Concept Design Road Safety Audit

**Hurlstone Agricultural High
School (Hawkesbury)
Londonderry Road, Vines Drive
and Southee Road**

Prepared for NSW Department of Education c/o Mace Australia Pty Ltd / 10 August
2018

161108 TAAE

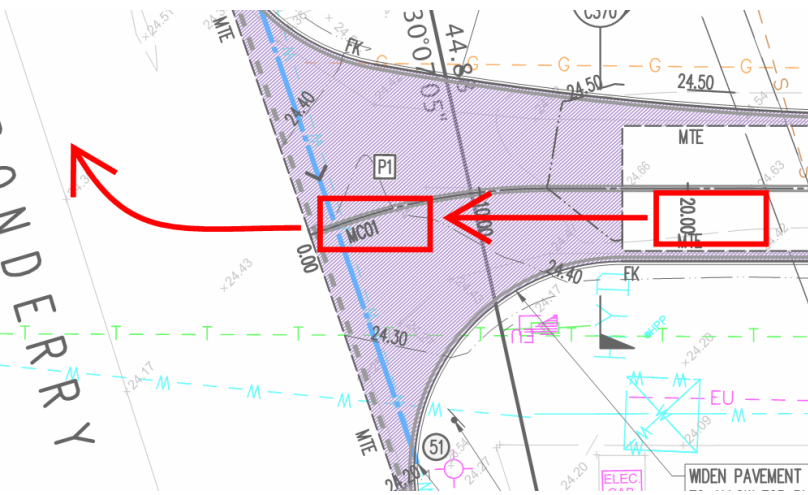
Item	Location	Identified Risks	Photographic Record	Frequency Severity Risk	Accept / Reject	Corrective Actions
INTERSECTIONS OF LONDONDERRY ROAD/VINES DRIVE AND LONDONDERRY ROAD/SOUTHEE ROAD						
1	Londonderry Road/Vines Drive	There is limited drainage located adjacent to Londonderry Road and Vines Drive. There is a risk that ponding water adjacent to the roadway may encroach the travel lane and result in vehicles aquaplaning and losing control. There is also a risk that drivers may swerve to avoid driving through water. These risks could lead to side impact or rear end collisions.		Improbable Minor Low	A	<p>Severe aquaplane risks are not considered to be evident at this location.</p> <p>Vines Drive consists of long straights and wide curves, providing good visibility of oncoming traffic in the event a vehicle is required to avoid water.</p> <p>Existing issue on external road is unlikely to be worsened by additional traffic.</p> <p>Operation is considered satisfactory.</p> <p>No further action.</p>
